14th September 2012

URGENT FIELD SAFETY NOTICE

Reserve battery and new instructions for users of the PAD 300/PAD 300P (Public Access Defibrillator)

Hang Tag

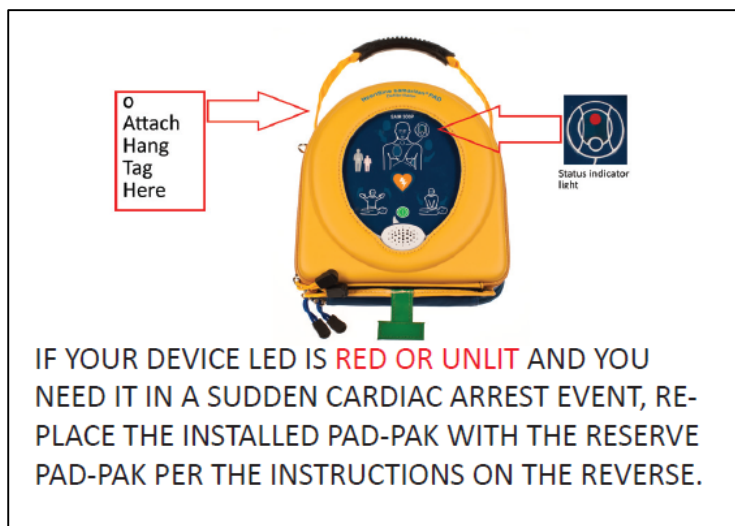
In addition, in **Annex III** of this Field Safety Notice we have shown a graphic of a hang tag for your device. This hang tag will instruct users how to install the reserve PAD-PAK battery should the existing battery appear to lack sufficient battery power during a patient event and will be provided to you at the same time as the Reserve Battery inside your upgrade kit.

6. When you receive the hang-tag, attach it to the handle of the PAD 300/PAD 300P soft carrying case to alert a first responder that they may need to replace the installed depleted PAD-PAK with the reserve PAD-PAK contained in the zippered pouch. Instructions for replacing the PAD-PAK are provided on the hang-tag.

Instructions for installing Reserve PAD-PAK

Remove Reserve Pad-Pak™ from its packaging.

Remove installed Pad-Pak™ by depressing the clips on either side and sliding it out from the device.

Place the samaritan® PAD and Pad-Pak™ on a flat surface.

Push Pad-Pak™ into the opening and listen for the "click" sound to ensure it is properly inserted

Once the Pad-Pak™ is installed properly the PAD STATUS INDICATOR will begin to blink Green every 5 seconds
